**ADDENDUM NUMBER:           FOUR**

**ISSUED BY:                   SEPW Architecture Inc.**  
109 – 3725 Pasqua St., Regina, SK. S4S 6W8  
PH. (306) 569-2255

**PROJECT:                    NEW POLICE BUILDING**

**ONION LAKE, SASKATCHEWAN**

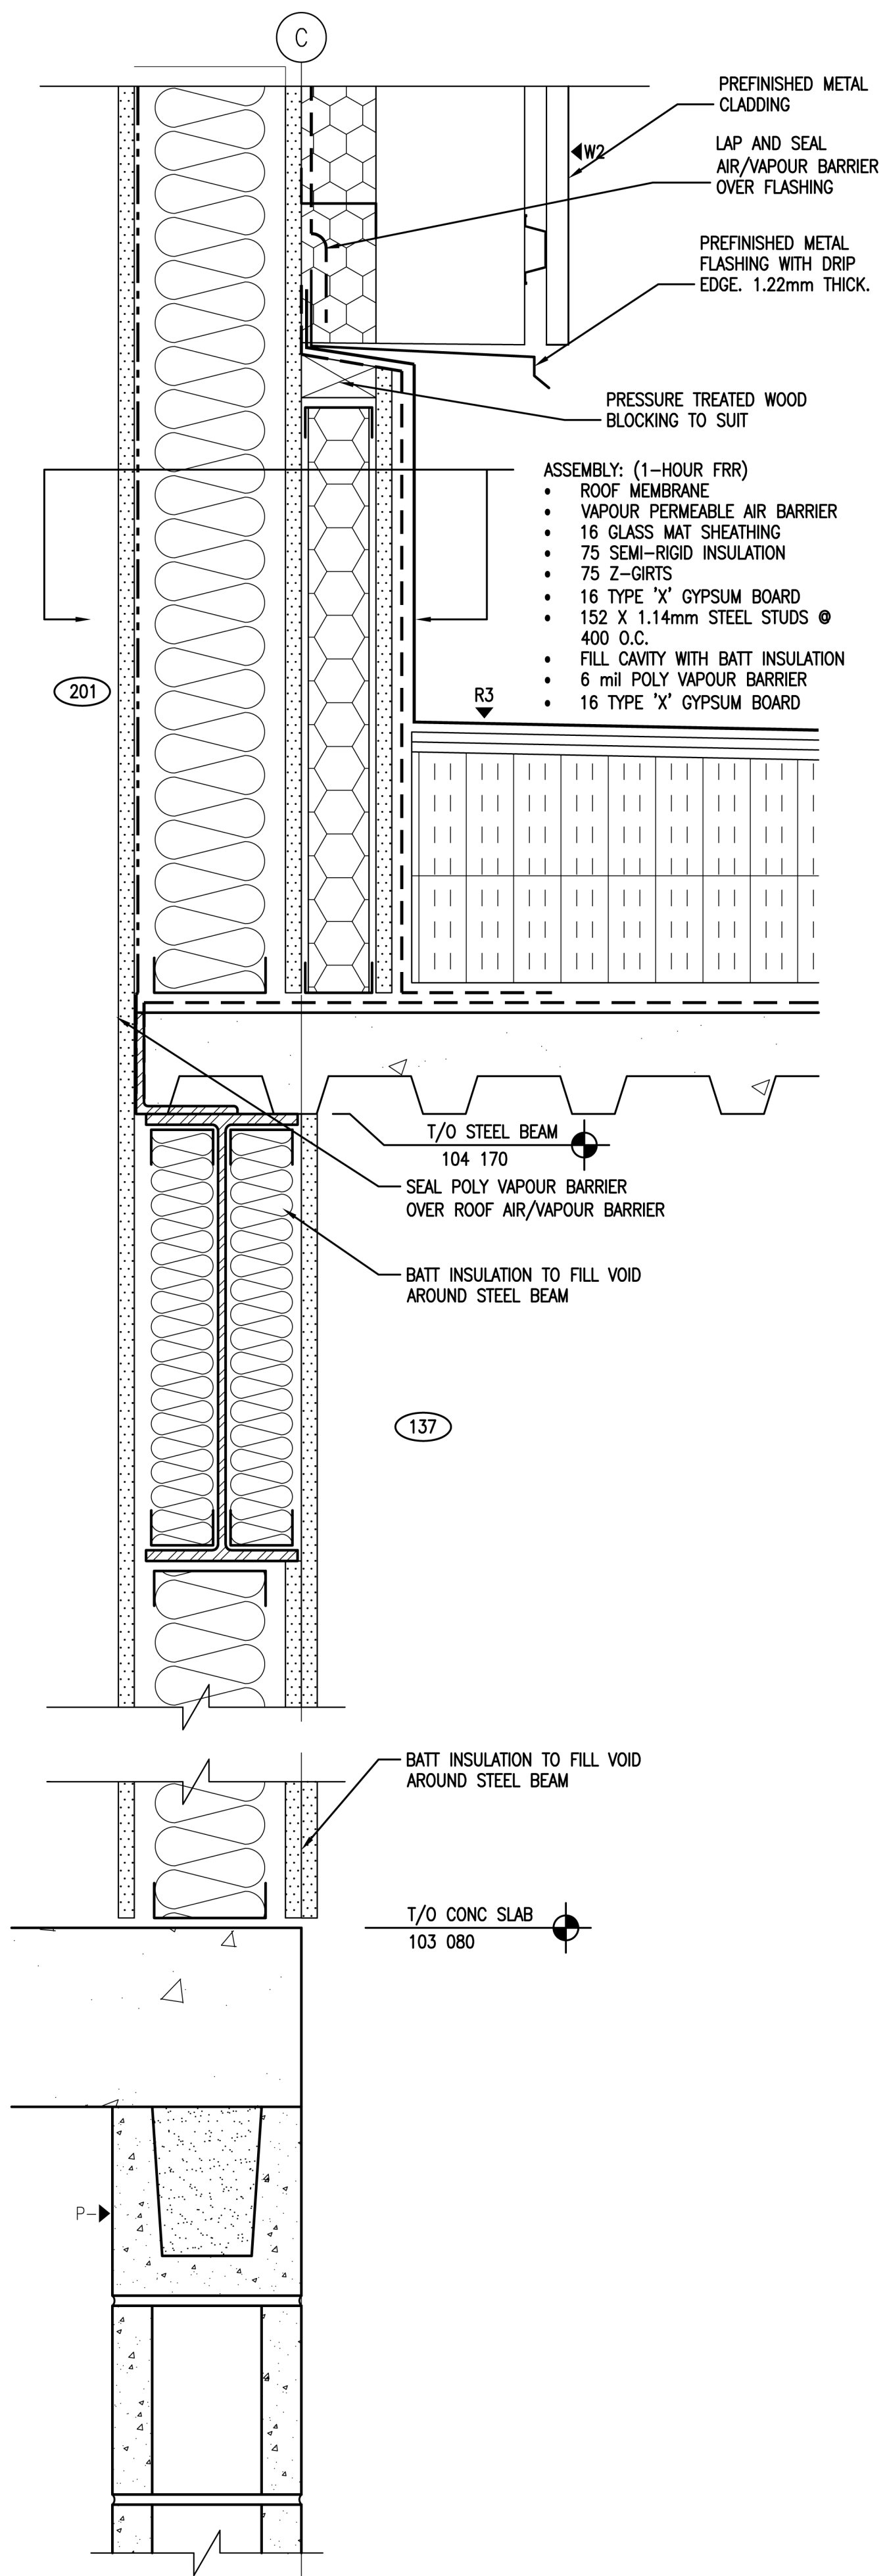
**A-4-14 REF. DRAWING A4.4 SECTION DETAILS**

1. Revise detail 5/A4.4 as indicated in sketch AR2.
